G.O. No. 224 (W) Press
Mis.

GOVERNMENT OF MADRAS.
PUBLIC WORKS DEPARTMENT.

Buildings and Roads.
Civil Works.

Junction Canal, ~~Indra~~
 Papers regarding the
 drainage of the Indragone
 and Kistnampe tt rivers
 across the ~~...~~ canal
 with remarks to the General
 Resident Municipal Com
 mission and Engineer for
 attention.

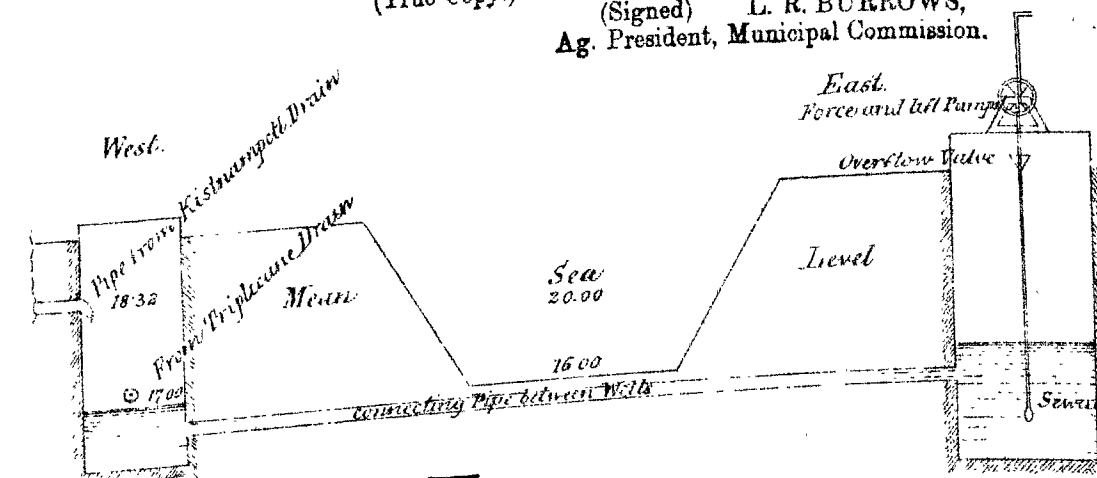
13. At Kistnampett farm two wells could be formed—one to receive the sewage on the east and the other from which to raise the sewage on the west. These two wells could be connected by a pipe as per sketch at end of this note. I recommend this instead of a syphon as I am afraid there would be a difficulty about keeping it clean.

14. There would be an extra lift of about 3 feet caused by the sewage passing under the canal, and the lifting this height of about 150,000 gallons a day (as near as I can calculate) would be entailed on the Municipality as a permanent charge by the formation of the Junction

15. Theoretically it may be said that the sewage will find its own level again on the east side of the canal and that there will be no extra lift, but in practice it will be found necessary to keep the sewage in the well east of the canal at a lower level than the outfall of the drains into the well on the west side; otherwise there will be stagnation of sewage in the drains and pipes.

It is proposed to construct a syphon similar to that shown in your rough sketch at the Kistnampett sewage farm to convey the sewage underneath the canal, and, if the Government will sanction a lift pump to raise it to the present level of the Kistnampett drain, I shall be prepared to erect it in site. Owing to recent instructions from His Grace the Governor, I have been compelled to alter the line of the canal again between Elliott's Road and the Kistnampett sewage farm, which new direction will necessitate your department relinquishing the whole plot of the farm lying between the narrow embankment on the west up to the drain on the east side and the ridge along which the sewage pottery pipes are laid. As regards the subject of the Government compensating the Municipality for the land taken up by the canal by handing over other ground lying to the southward to them, I am not permitted to express an opinion, for it is not a matter that I ought to interfere in whatever private opinion on the subject may be.
